APPENDIX 21

UNITIZING PROCEDURES FOR PROPELLING CHARGES PACKED IN CYLINDRICAL METAL CONTAINERS ON 4-WAY ENTRY PALLETS

PAIOO SERIES CONTAINER

REVISION NO. 1, DATED JULY 1986, CONSISTS OF:

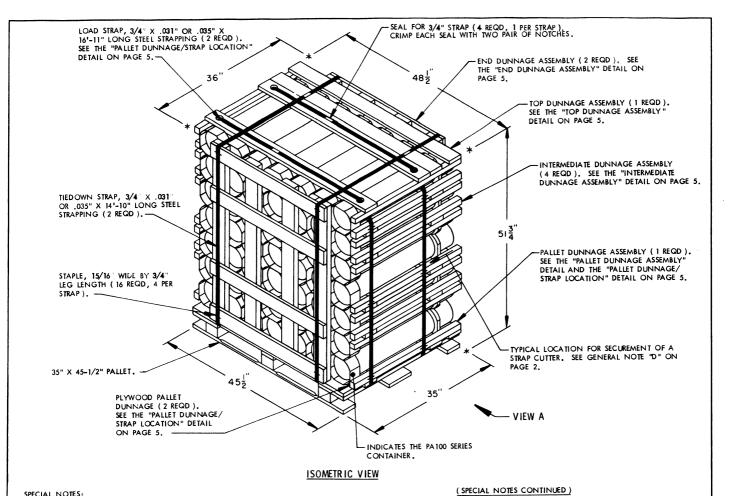
CHANGING 1-1/4" STRAPPING TO 3/4" STRAPPING.
